A. Engine 601

Cylinder block/crankcase (starting 10/84)

B. Engine 602, 603

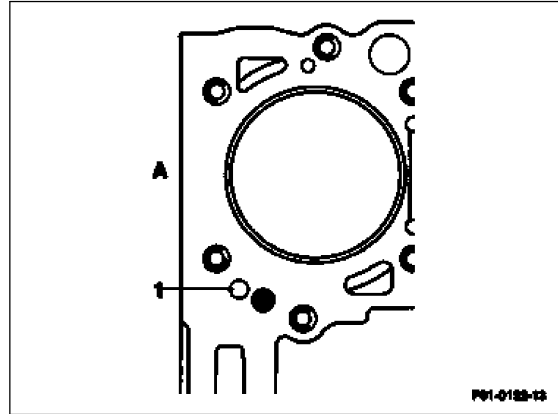
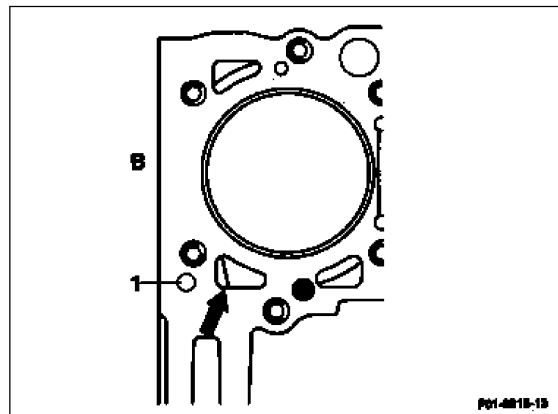
On this cylinder block the hole for the fitted sleeve (for locating the cylinder head) has been moved farther toward the rear (shaded circle) and the oil passage (1) farther toward the front.

Cylinder head:

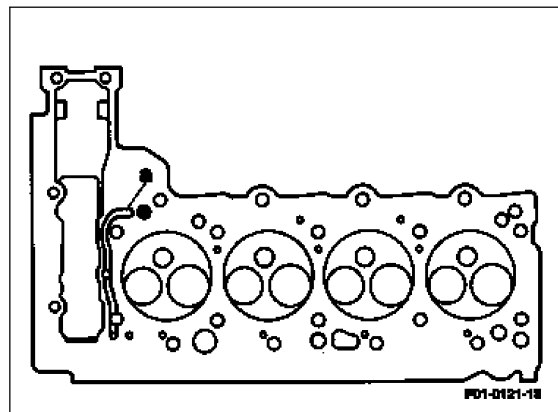
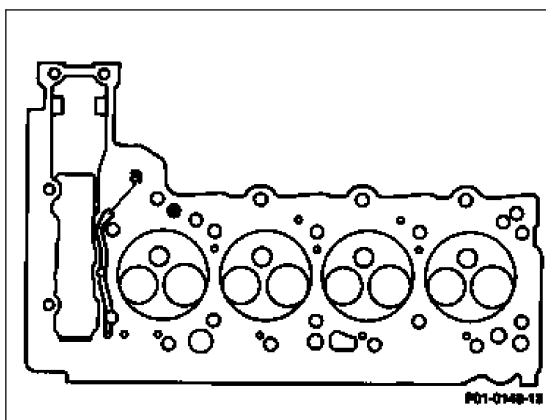
The following modifications were necessary due to the new positions of the fitted sleeves and oil passages in the cylinder block.

The fitted sleeve centering was moved farther toward the rear (shaded circle). The lateral groove (a) for lubrication of the camshaft bearings and the hydraulic elements is shorter.

Cylinder head gasket:

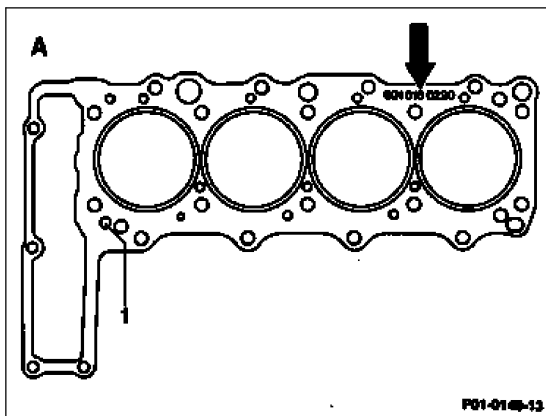
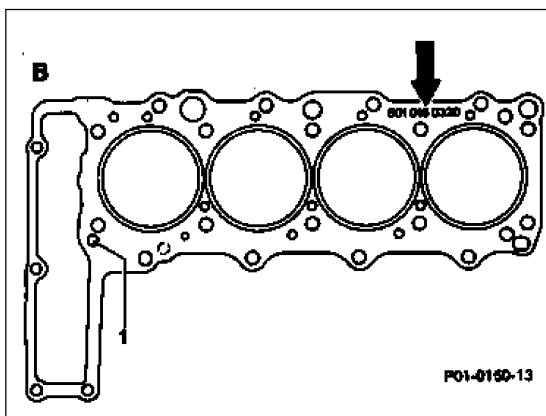
The cylinder head gasket was also modified to match the new positions of the fitted sleeves and oil passage in the cylinder block.

Precombustion chamber mounting bore

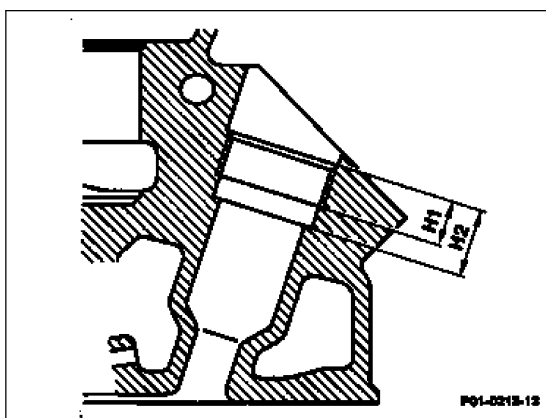
As of 04/85 the height (H1) of the thread in the precombustion chamber mounting bore was increased 2 mm for a total of 15 mm. Dimension H2 is 22.5 mm.

Cylinder head gasket

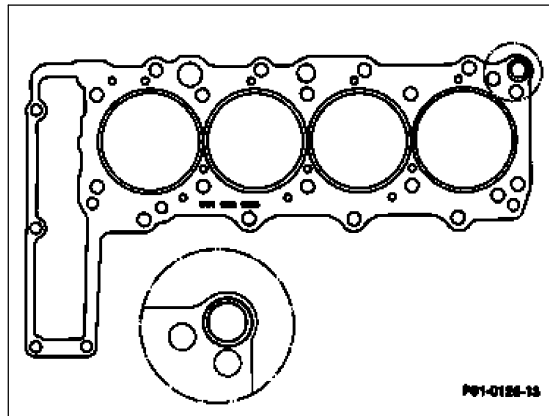
A cylinder head gasket from a different manufacturer (Elring) was installed for a short time (from 04-05/88).

On this cylinder head gasket the oil return duct (showing in circle) is equipped with a Viton seal.

Combustion chamber recess

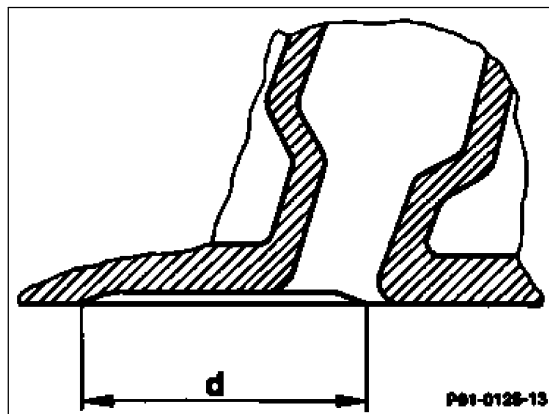
The size of the combustion chamber recess (d) was increased to reduce the thermal load in the cylinder head. Production breakpoint 06/88.

Differentiation of cylinder heads for naturally aspirated and turbo-engines

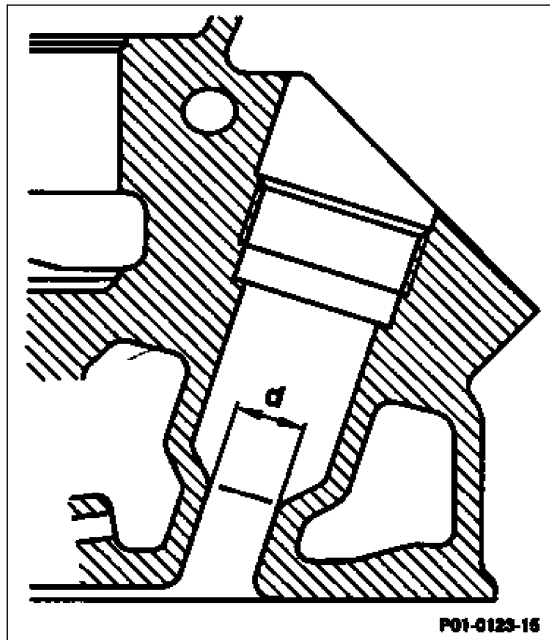
The cylinder heads for turbo-engines 602.96, 603.96 and 603.97 are reinforced at the water jacket due to the higher combustion pressures.

On turbo-engines the diameter (d) of the pre-combustion chamber bore is 15 mm, on naturally aspirated engines 14 mm.

P01-0123-15

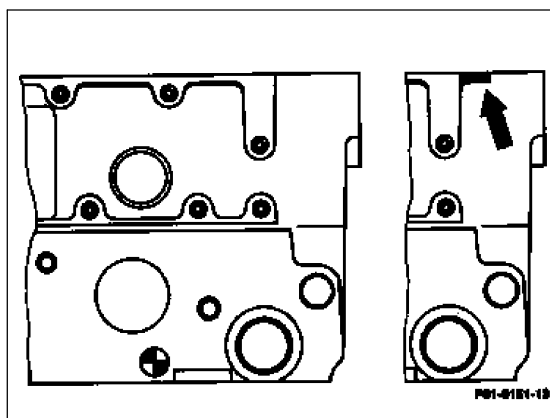
The cylinder heads on turbo-engines are provided with an identification strip. This identification strip (arrow) is located on the parting surface for the cylinder head cover at the front right.

Do not mix up cylinder heads for turbo-engines and naturally aspirated engines.

P01-0121-13

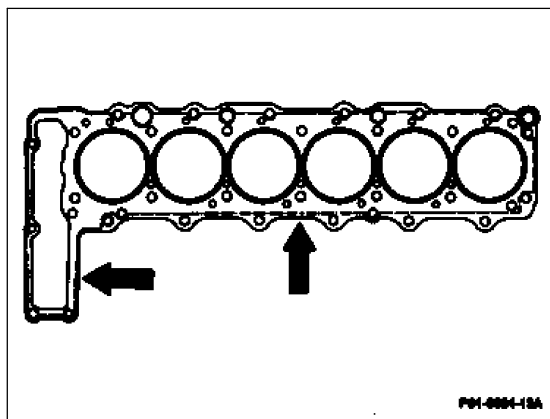
The cylinder head gasket for the turbo-engines has stainless steel inserts around the combustion chambers (arrow).

The combustion chamber inserts on the standard gaskets installed on naturally aspirated engines consist of normal sheet steel.

Only the cylinder head gaskets with stainless steel inserts are available as replacement parts for both the naturally aspirated and turbo-engines.

Cylinder head gasket with Viton sealing ring

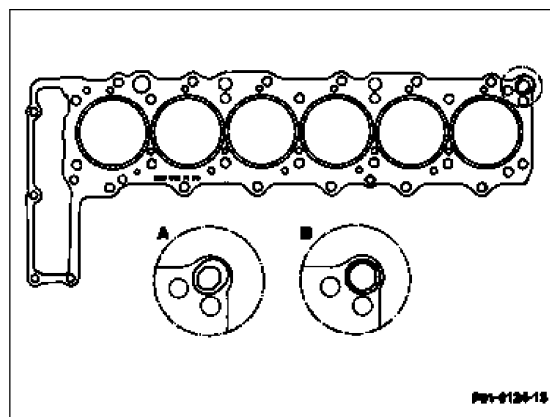
Since 03/87 a Viton sealing ring is inserted at the rear oil return passage to prevent oil leakage.

- A 1st version with sheet metal jacket
- B 2nd version with Viton sealing ring

Modifications in area of timing chain case

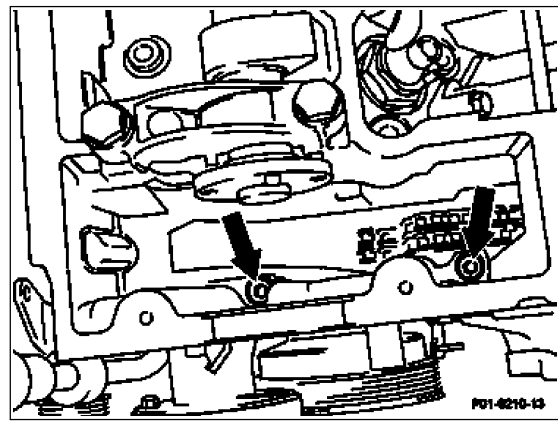
Since 09/87 on engine 602.91 and since 10/87 on engine 603.91 for production reasons the height of the bridge in the cylinder head in the area of the timing chain case was increased to 32 mm (previously 12 mm).

This modification made it necessary to change the dimensions of the two cylinder head bolts (arrow). The new bolt length is M 8×50 (previously M 8×30).

Cylinder head gasket for improved sealing

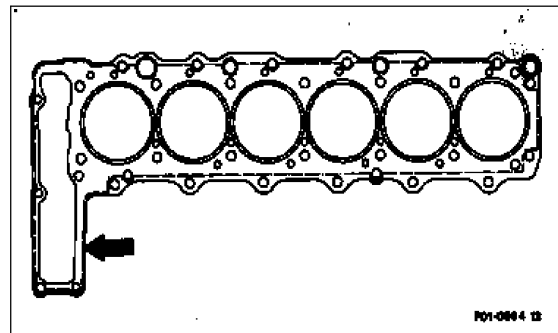
The cylinder head gasket has been equipped with circumferential silicone sealing strips (arrow) on both sides and a Viton sealing ring at the oil return passage at the rear right to better prevent water and oil leakage.

Cylinder head gasket, engines 602, 603 (except for engine 603.970)

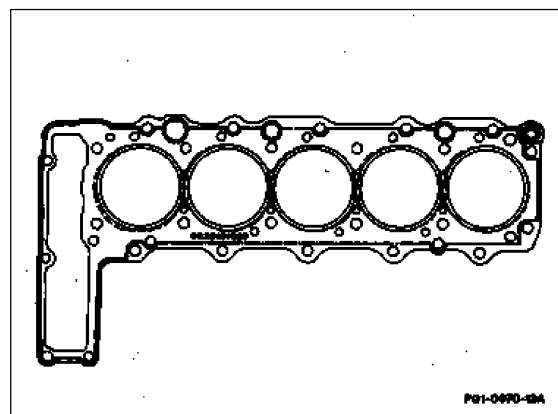
The combustion chamber insert (dotted line) has been modified at the 1st cylinder on the cylinder block side as of 01/90.

Cylinder head gasket, engine 603.970

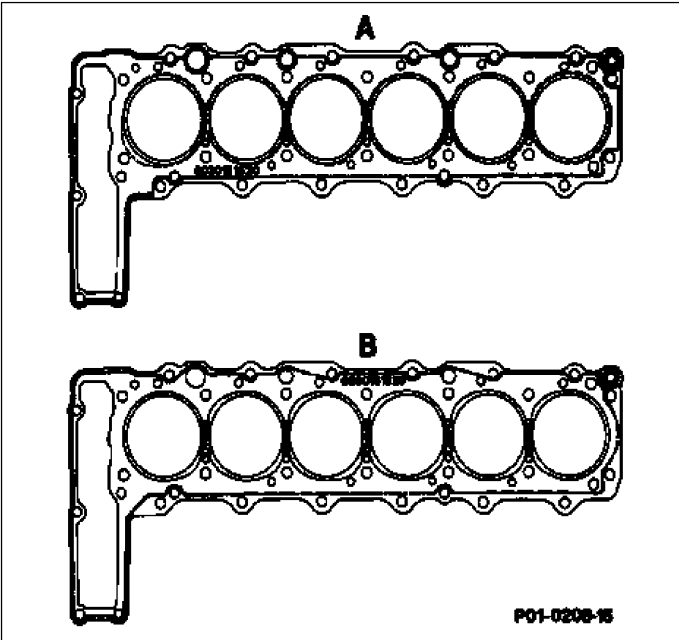
As of 01/90 combustion chamber insert modified Silicone sealing strip position changed on both sides.

- A. 1st version (Gütze)
- B. 2nd version (Elring)
